## Comment Letter O2

## Response to Comment Letter O2

Re: Soitec Solar Development Program Environmental Impact Report, Log No:  
PDS2012-3910-12005  
Tierra del Sol, 3300-12-007

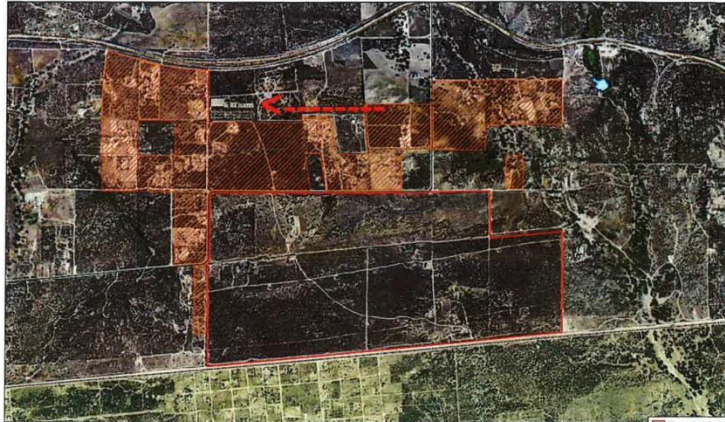
1. Our observatories are located within the map indicating 'sensitive' properties (red crosshatch below). Parcels to our south, east and west are 'sensitive', map figure EIR 2.5-4. Below is the map with an arrow pointing to our property. PEIR page 2.5-26 describes 'sensitive' land uses, but provides no criteria. Our question is: what are the criteria for 'sensitive'? The San Diego Astronomy Association believes our dark night sky observatories at TDS are clearly 'sensitive' to the proposed solar farm night lighting.

2. The next corollary question is whether designation as 'sensitive' impacts our ability to ask/require mitigation measures be required/accepted by the proposer? Do we need to be designated as 'sensitive' to request mitigation; how does the 'sensitive' designation affect our mitigation requests.

The County of San Diego (County) notes the location of the San Diego Astronomy Association's (SDAA's) property. The commenter references Figure 2.5-4 of the Draft Program Environmental Impact Report (DPEIR), which identifies residential properties proximate to the Tierra del Sol solar farm as "sensitive." These residential properties were identified in this chapter (Chapter 2.5 of the DPEIR) to evaluate whether the Proposed Project would "physically divide an established community." Including the commenter's identified property in the analysis would not change the DPEIR's conclusion that the Proposed Project would not cause a significant impact by physically dividing an established community. The County notes the commenter's assertion that its dark sky observatories are sensitive to the Tierra del Sol solar farm's night lighting. Nonetheless, in response to this comment, Figure 2.5-4 of the DPEIR has been revised to identify the SDAA property at 961 Tierra De Luna Road as a sensitive land use. See also Response to Comment O1-6.

As explained in response to comment O2-1, receiving a designation as a "sensitive" receptor in Section

2.5.3.1 would not impact the commenter's ability to ask that the Tierra del Sol solar farm employ mitigation measures to avoid dark sky impacts to the commenter's observatory activities. The commenter is referred to the DPEIR's discussion of dark sky impacts for the Tierra del Sol solar farm, which will be less than significant (see DPEIR, Section 2.5.3.1).

See also the responses to comments O1-2 and O1-4. Chapter 2.1 of the DPEIR has been revised to clarify that lighting at the Tierra del Sol solar farm would comply with Zone A lighting standards and that all security lighting would be fully shielded and motion-sensor controlled, and would be turned off when no one is on site.
